Land Use Petition RZ-23-0001, VC-23-0002 and VC-23-0003

PROJECT LOCATION:	5805 State Bridge Road
DISTRICT/SECTION/LAND LOT:	1 st District, 1 st Section, Land Lots 299 and 330
ACREAGE:	8.65 acres
CURRENT ZONING:	C-1 (Community Business District) Conditional
PROPOSED ZONING:	C-1 (Community Business District)
COMPREHENSIVE PLAN COMMUNITY AREA DESIGNATION:	Medlock
APPLICANT:	Willow Capital Partners, LLC c/o Tyler Morris 525 Pharr Road NE Atlanta, GA 30305
OWNER:	Medlock Associates, L.P. 525 Pharr Road NE Atlanta, GA 30305
PROPOSED DEVELOPMENT:	To allow for an outparcel development to construct a 3,500 SF restaurant with drive-through, and two concurrent variances: <ul style="list-style-type: none">• VC-23-0002: to reduce the required parking from 355 to 299 spaces• VC-23-0003: to eliminate landscape strips along interior property lines
STAFF RECOMMENDATION:	Approval with Conditions

Site Plan

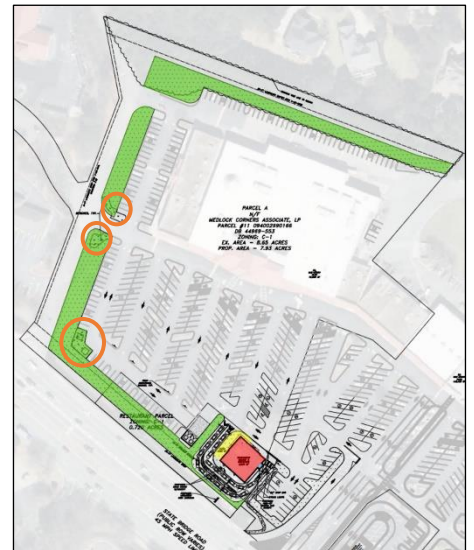
The site plan shows a 3,500 square-foot restaurant building (shown in red) with 1,220 square-foot outdoor patio (highlighted in yellow). The area is presently underutilized parking for the shopping center. The plan shows a single pick-up window (highlighted in blue) fed by two drive-through lanes providing stacking for up to 23 vehicles. The proposed menu boards and speaker posts (outlined in purple) are placed behind the building along State Bridge Road.

With the addition of the outparcel development there will be 299 parking spaces remaining to serve the entire site. The Applicant has proposed sidewalks and crosswalks connecting the existing sidewalk along

State Bridge Road to the main entrance of the proposed building.

The site plan also shows open space (highlighted in green) distributed around the perimeter of the site with the addition of three distinct seating areas (outlined in orange) within the existing open space, to include benches and tables surrounded by ornamental landscaping, specialty pavers, boulder wall and stepping stones. The Applicant proposes to shift the internal driveway 60 feet north, away from State Bridge Road, to align with the relocated driveway design approved as part of the Scooter’s rezoning, to complete the other half of improvement for the main driveway providing safer in and out access for the shopping center. All other existing driveways, curb cuts, landscape strips and zoning buffers will remain intact.

2. The site shall be developed in general accordance with the site plan received and date stamped on June 5, 2023. Said site plan is conceptual and the final site plan must meet or exceed the land development regulations and zoning conditions prior to the approval of a land disturbance permit.

4. Owner/Developer shall allocate a minimum of 10% of the site as common usable open space, as shown on the site plan received and date stamped on June 5, 2023. Owner/Developer shall provide

7. Owner/Developer shall provide sidewalks and crosswalks to connect the proposed building to the existing sidewalk on State Bridge Road as shown on the site plan received and date stamped on June 5, 2023, subject to the approval of the Public Works Director.

Elevations

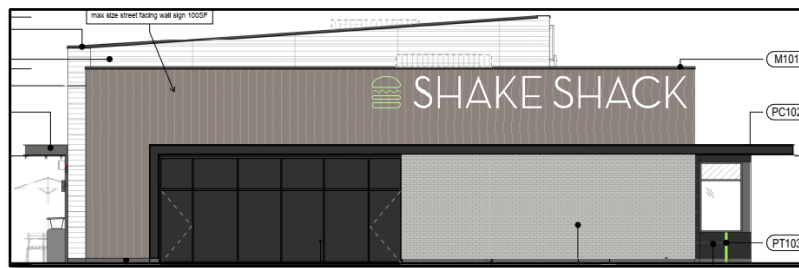
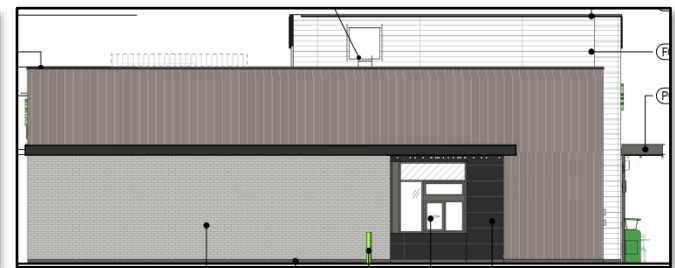
The submitted elevations indicate the building façade would be constructed primarily of cementitious siding and EIFS, which are compliant with the requirements of Section 4.4 of the Zoning Ordinance. The building has a flat roof design, façade offsets, contrasting building color and glass windows that would provide variation of the building façade.

3. Exterior elevations shall be substantially similar to the elevations received and date stamped on May 19, 2023. Final elevations shall be subject to the review and approval of the Community Development Director, prior to issuance of a building permit.

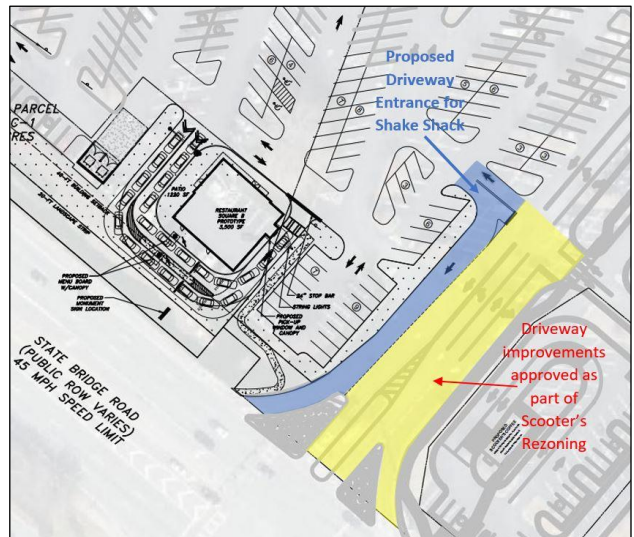
The proposed development would not adversely affect the use or usability of adjacent or nearby properties with the redesign of the driveway into the shopping center. The improvement to the shopping centers ingress/egress driveway as shown on the site plan would further enhance the traffic flow and minimize conflict points that had previously impacted the ingress/egress movements for the shopping centers. The proposed design of the drive-through for Shake Shack restaurant allowing for ample vehicle stacking and directing the traffic flow in a single direction would further improve the ability for patrons of the shopping center to safely maneuver in and out of the site.

With the condition of the site plan reflecting the relocation of Driveway A and its alignment with Driveway B to improve internal traffic flow within the shopping center, the proposed development would not cause an excessive or burdensome use of existing streets.

8. Owner/Developer shall incorporate on the site the traffic study recommended driveway configuration and as also shown on the site plan received and date stamped on June 5, 2023, subject to the approval of the Public Works Director.
